Access Compliance Report

Public Rights-of-Way

Intersection ID: 31910	Main Street: PALOMAR_MOUNTAIN_DR	Cross Street: STOWE_DERBY_DR	Location: NE
ADA ID: 10A731226E5F	Ramp Type: PerpDiag	Initial Pass/Fail: Fail	Overall Compliance: No
Severity Score: 21.25			
Codes/Mitigation Info/Possible Solution		Field Measurements/Component Compliance

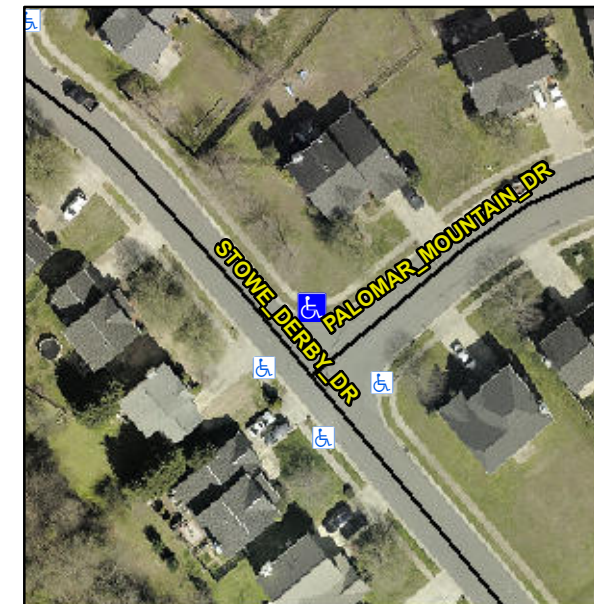
R304.5.1, R304.2.2

Compliance	Description	Data	Compliance	Description	Data
N/A	Ramp Length (in)	48.0	No	Ramp Slope (%)	9.5
No	Ramp Width (in)	47.0	Yes	Ramp XSlope (%)	0.8
N/A	Flare Type LT	N/A	N/A	Flare Type RT	N/A
N/A	Flare Slope LT (%)	N/A	N/A	Flare Slope RT (%)	N/A
N/A	Flare Traversable LT?	N/A	N/A	Flare Traversable RT?	N/A
N/A	Landing Length (in)	N/A	N/A	DWS Provided?	N/A
N/A	Landing Width (in)	N/A	N/A	DWS Contrast?	N/A
N/A	Landing Slope (%)	N/A	N/A	DWS Length (in)	N/A
N/A	Landing X Slope (%)	N/A	N/A	DWS Full Width?	N/A
N/A	Landing Curb? (Y/N)	N/A	N/A	DWS Offset (in)	N/A
N/A	Shared Landing?	N/A			
N/A	Gutter Ponding?	N/A	N/A	Gutter Slope (%)	N/A
N/A	Gutter Lip Ht (in)	N/A	N/A	Gutter X Slope (%)	N/A
N/A	Painted X Walk1?	No	N/A	Painted X Walk2?	No
	X Walk 1 Direction	To SW		X Walk 2 Direction	To SE
N/A	X Walk 1 Width (in)	N/A	N/A	X Walk 2 Width (in)	N/A
	X Walk 1 Slope (%)	1.8		X Walk 2 Slope (%)	2.8
	X Walk 1 X Slope (%)	2.9		X Walk 2 X Slope (%)	1.9

N/A	Ramp inside XWalk1?	N/A	N/A	Ramp inside XWalk2?	N/A
	Road Slope (%)	0.5	N/A	Clear Space?	N/A
	Road X Slope (%)	6.2	N/A	Clear Space to XWalk (in)	N/A
N/A	Any Obstructions?	N/A	N/A	Storm Grate/Utility Hazard?	N/A
	Obstruction Type			Storm Grate/Utility Type	
		N/A			N/A
		Yes		Surface Condition? (G/P)	Good

Remove & Replace Curb Ramp With Two New Directional Ramps or Equivalent.
